**Date:** 09/14/2020  
**RFB No:** 2020-051  
**Commodity:** Street Improvements – 2019 Reclamation Phase 1  
**Purchasing Agent:** Mr. Kasey Gamblin

**Addendum No: 1**  
**Questions and Answers**  
**Changes to Specifications and Drawings**  
**Updated Bid Form**

**BID PROPOSAL FOR  
STREET IMPROVEMENTS 2019 RECLAMATION PHASE 1 (18ST2003C)**

STREET IMPROVEMENTS  
2019 RECLAMATION PHASE 1  
TYPICAL STREET SECTIONS

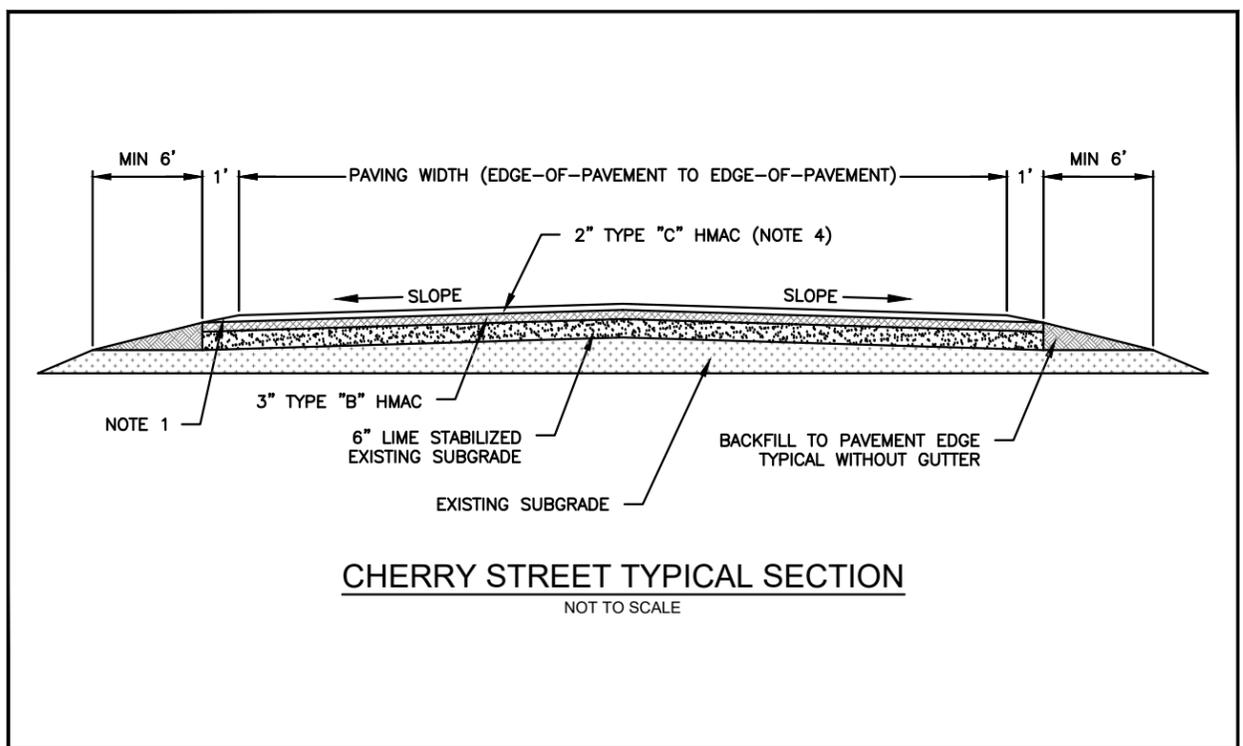
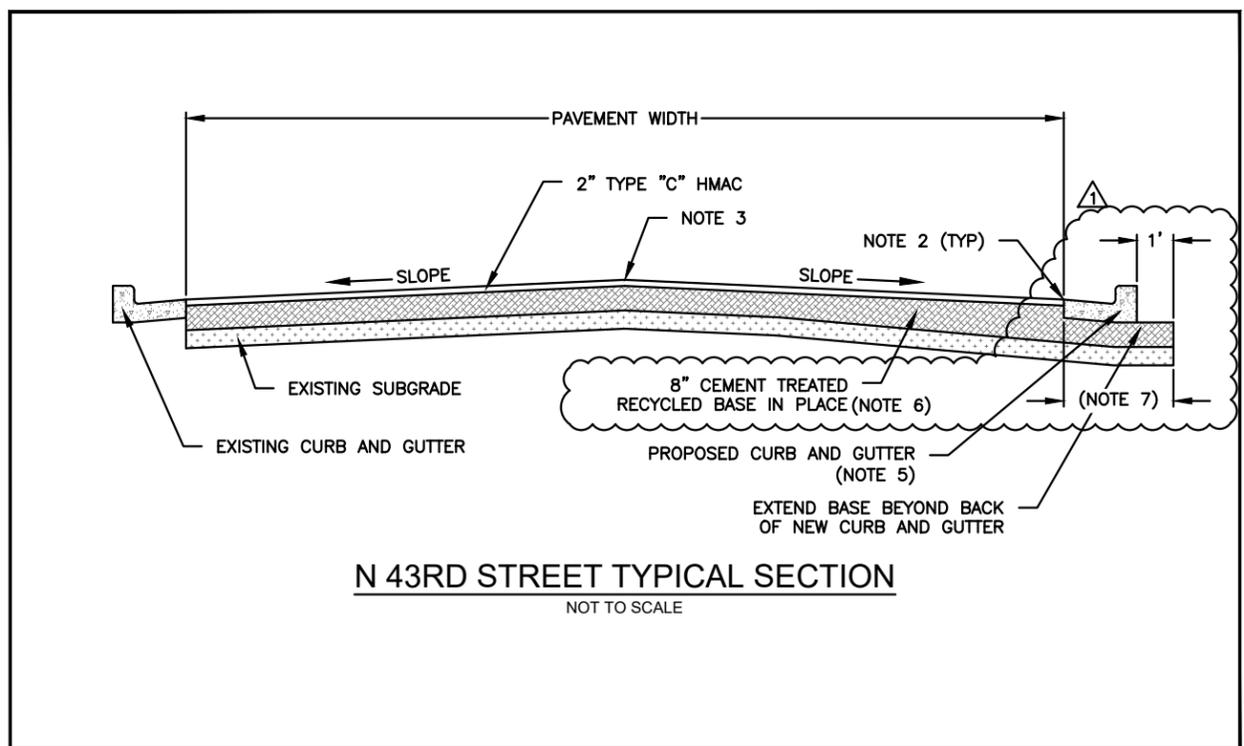
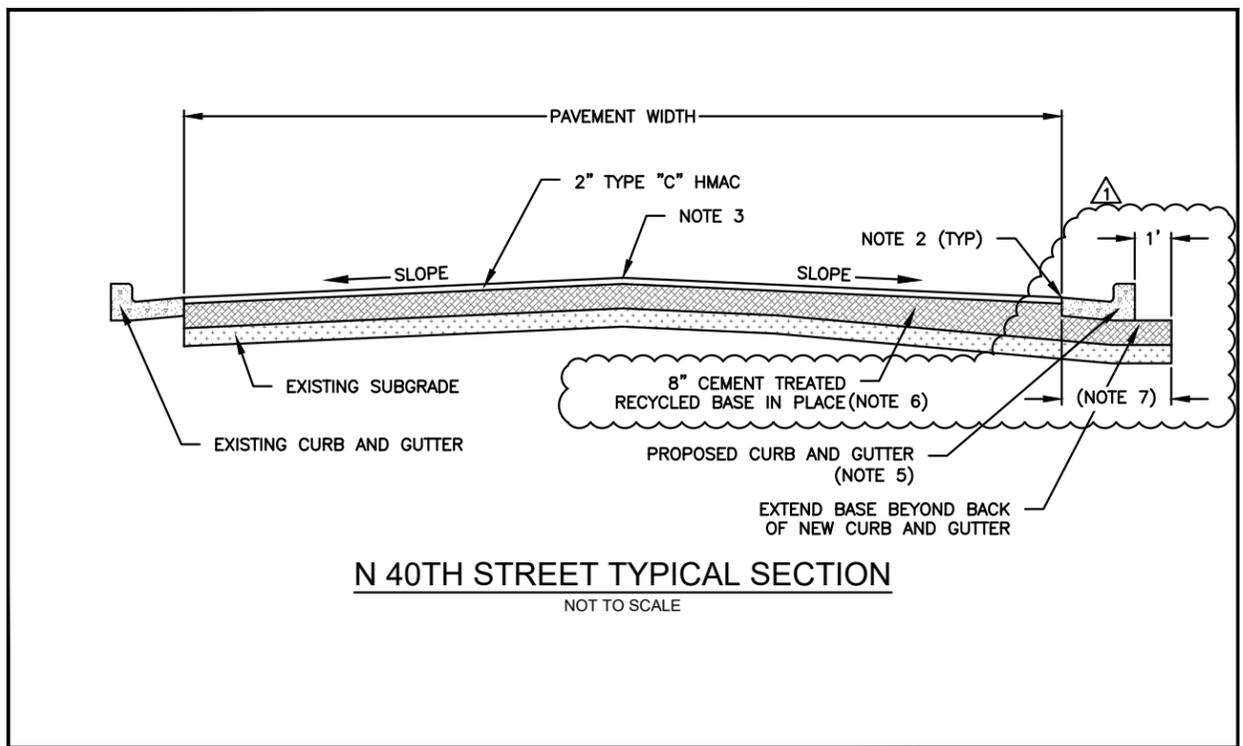
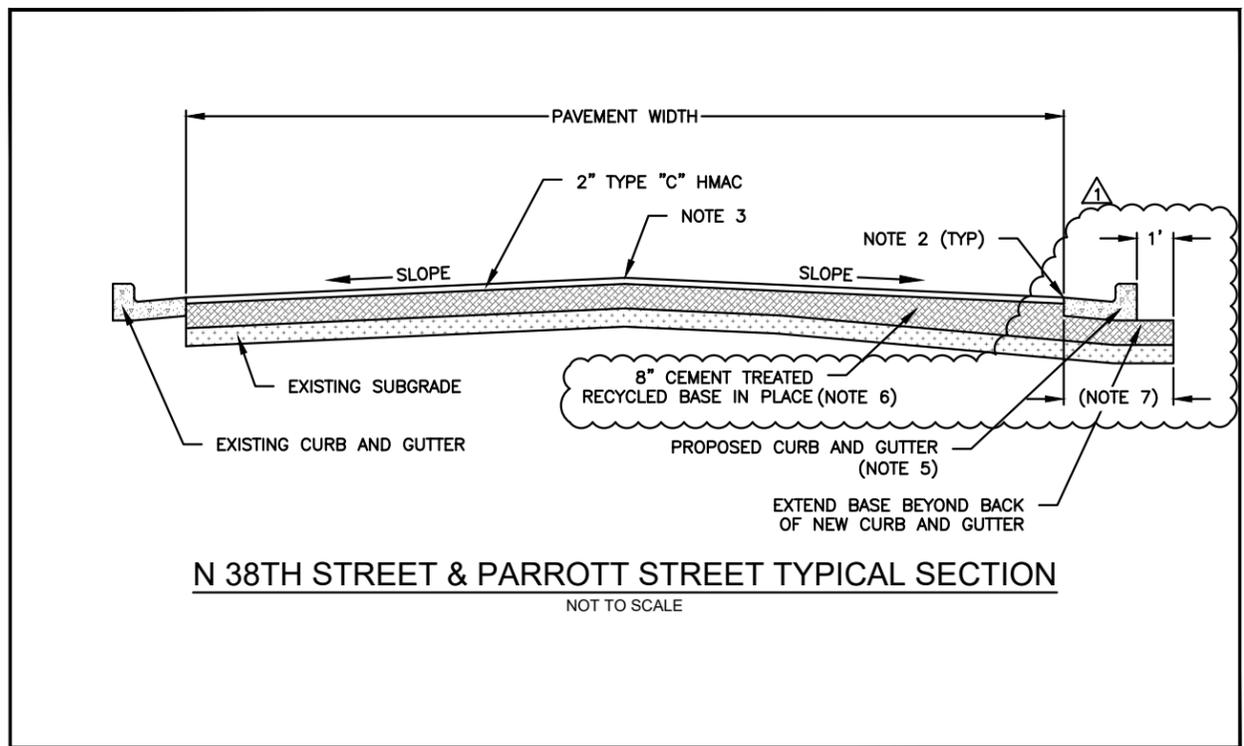
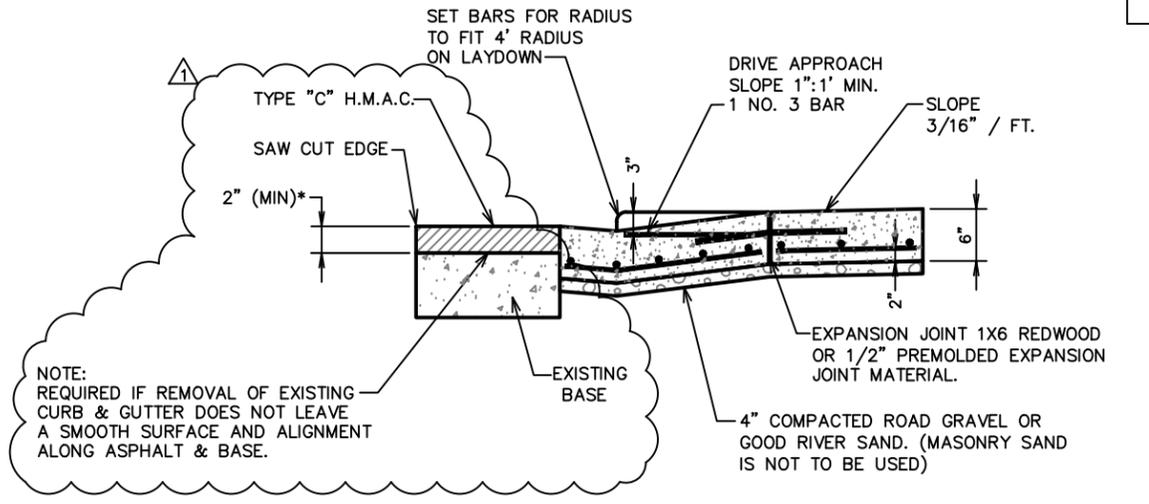
5. Schedule of Summary Sheet C004 shows 203 SY of 2" D-GR TY C for overlay and reclamation (Items 6 and 13) on Parrott Ave. Is this a double up?
6. The typical street sections on C418 for N 38th, Parrott, N 40th and N 43rd Streets show 8" CEMENT TREATED RECYCLED BASE IN PLACE from the front of existing curb, to what looks like 1'-0" behind back of new curb. The pay quantity for CEM TREAT RECY BASE is the same as the 2" TY-C quantity which is face of curb to face of curb for each street.

- a. Shouldn't the pay quantity for CEM TREAT BASE be higher, to encompass the CEM TREAT BASE under new curb areas?
  - b. If the new CEM TREAT BASE extends beyond the proposed curb, will there be enough existing roadway material to do this?

- c. How would the excavation and haul off for the CEM TRT BASE under new curbs be paid for?
7. Sheet C801 has two notes that state Curb and Gutter to be paid for separately from the concrete valley gutter at the contractor unit price for curb and gutter. The various plan sheets have notes that state that CONCRETE CURB IS SUBSIDIARY TO VALLEY GUTTER AND FILLET BID ITEM. Please clarify the contradicting notes.

- a. The cement treated base required under and 1'-0" behind the proposed curb and gutter as shown on Sheet C418 shall be considered subsidiary to the PROPOSED CURB AND GUTTER bid item.

- b. There will not be enough existing material to use for cement treated base under and behind proposed curb and gutter. Contractor shall import cement treated base material.

- c. Excavation and haul off in preparation for the cement treated base under and behind the proposed curb and gutter shall be considered subsidiary to the PROPOSED CURB AND GUTTER bid item.Sheet C418 has been revised to clarify.
